PUBLIC HEARING MEMORANDUM

SUBJECT: **Petition #169-20**, for SPECIAL PERMIT/SITE PLAN APPROVAL to change the existing nonconforming use from the existing two-family use to three single-family dwellings on one lot, and to determine appropriate density and dimensional controls at **148 Pine Street**, Ward 4, on land known as SBL 44, 17, 32, containing approximately 18,235 square feet of land in a district zoned SINGLE RESIDENCE 3. Ref: §3.1.3, §3.4.1, §5.4.2.B, §7.3.3, §7.4, and §7.8.2.C.2 of the City of Newton Rev Zoning Ord, 2015.

MEMORANDUM

Re: Special Permit – 148 Pine Street

Proposed Site Plan

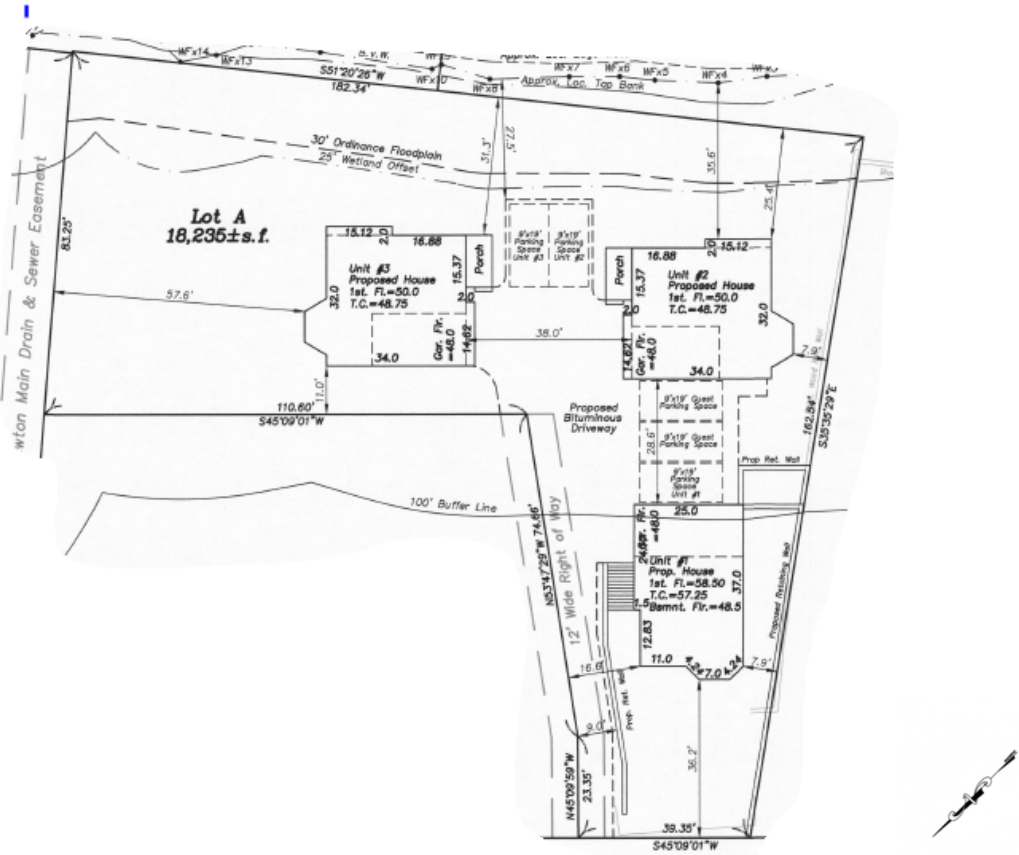
The front setback allows for a cohesive neighborhood context in how structures relate to the street and can provide an overall neighborhood character if structures are similarly set back from the street. Due to the shape of the lot, Unit 3's front setback is measured from the rear lot line of the abutting parcel. The Planning Department is unconcerned with the front setback of Unit 2; however, 11 feet is not desirable for the separation of Unit 3 from the abutter's property at 146 Pine Street. When comparing to the standards for a single-family detached dwelling on a rear lot, which this configuration is most similar to, a 30-foot front setback from the front lot is required for a principal structure. Additionally, the front setback of 36 feet for Unit 1 would not align with the rhythm of Pine Street because many dwellings are on the street providing presence on the street, but are also keeping the large grade change to the rear, hidden from view. The dwellings at the rear will not have a connection to the street and placing Unit 1 further from the street visually exacerbates the grade change

The Planning Department has concerns with the front setbacks of Units 1 and 3 as well as the lot area per unit proposed at 6,078 square feet. The Planning Department would like more information from the petitioner that shows sections of the proposed three single-family dwellings from all elevations.
